RENESAS TECHNICAL UPDATE

Product Category	MPU/MCU		Document No.	TN-RZ*-A0088A/E	Rev.	1.00
Title	RZ/G2H, G2M V1.3, V3.0, G2N and G2E Add Descriptions for DU	Information Category	Technical Notification			
	RZ/G Series, 2nd Generation	Lot No.				
Applicable Product	olicable RZ/G2H		Reference Document	RZ/G Series, 2nd Generation User's Manual: Hardware Rev.1 (R01UH0808EJ0110)		.10

Additional Descriptions for "RZ/G Series, 2nd Generation User's Manual: Hardware Rev.1.10".

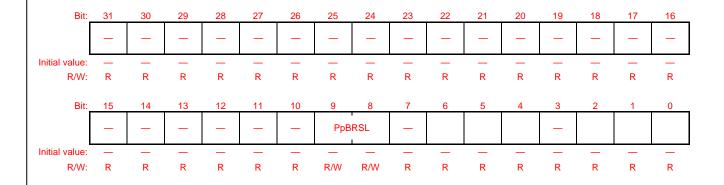
3. Section 36. DU, Page 36-99, 36.2.4 Display Plane Registers, (1) Plane p Mode Register m (PpMRm). Concerning alpha blending setting description added.

Add precautions when using alpha blending

If enable α blending on the DU, the value of non-disclosed register that is not initialized by reset may refer to the other Plane as α value and unexpected image is output. Disclosed the above registers for using with software workaround.

Correction	(to):				
Bit	Bit Name	Initial Value	R/W	Internal Update	Description
14 to 12	PpSPIM	B'000	R/W	Available	Plane p Super Impose Mode [(DU0/DU1)]
					B'000: Setting prohibited.
					B'001: Setting prohibited.
					B'010: Setting prohibited.
					B'011: Setting prohibited.
					B'100: Transparent color processing is not performed for plane

p. Plane p is displayed.
					B'101: α blending of plane p and the lower plane is performed. The transparent color specification for plane p is ignored, and α blending is performed between all the pixels of plane p and the lower plane. This setting is prohibited if α blending is not used. When
					α blending has been set, set the PpBRSL in PpALPHARm to B'00.
					B'110: An EOR operation is performed on plane p and the lower plane. The transparent color specification for plane p is ignored, and EOR operation is performed on all the pixels of plane p and the lower plane.
					B'111: Setting prohibited
					Plane 1 Super Impose Mode [RZ/G2M V1.3, RZ/G2M V3.0(DU2)]
					B'000: Setting prohibited.
					B'001: Setting prohibited.
					B'010: Setting prohibited.
					B'011: Setting prohibited.
					B'100: Transparent color processing is not performed for plane
